Model: Phoenix II /Cattleya/Iris/Lilac (ADF)		Date: 15-Sep-99	No.: RA204010
Subject: ADF Jam		Prepared by: H.Matsui	
From: Technical Service Dept., GTS Division			
Classification:	<input checked="" type="checkbox"/> Troubleshooting <input type="checkbox"/> Part information <input type="checkbox"/> Action required <input type="checkbox"/> Mechanical <input type="checkbox"/> Electrical <input type="checkbox"/> Service manual revision <input type="checkbox"/> Paper path <input type="checkbox"/> Transmit/receive <input type="checkbox"/> Retrofit information <input type="checkbox"/> Other ()

No.: RA204010

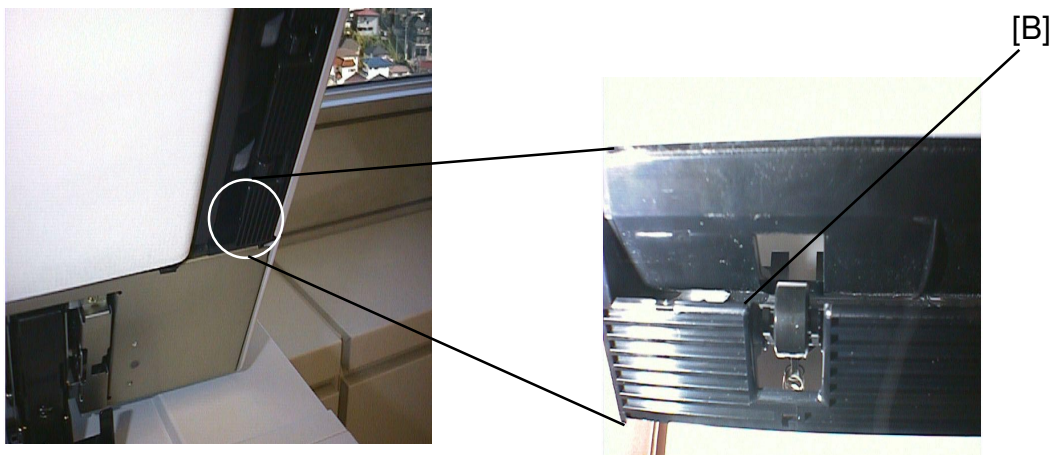
When feeding small size originals lengthwise, a original jam may occur in the area on the exposure glass where the original is to be fed out (position [A]).

The rear side of the leading edge of the originals catches ridge [B] (this ridge was created during the molding process), near one of the ribs of the paper inverter guide plate (P/No. A5481210).

Until the permanent countermeasure is implemented, the ridge [B] should be smoothed down (remove if possible) with sandpaper.

From the serial numbers in the following table, a permanent countermeasure will be applied (the mold used to produce the inverter guide plate will be repaired). Therefore, the above action should not have to be done.
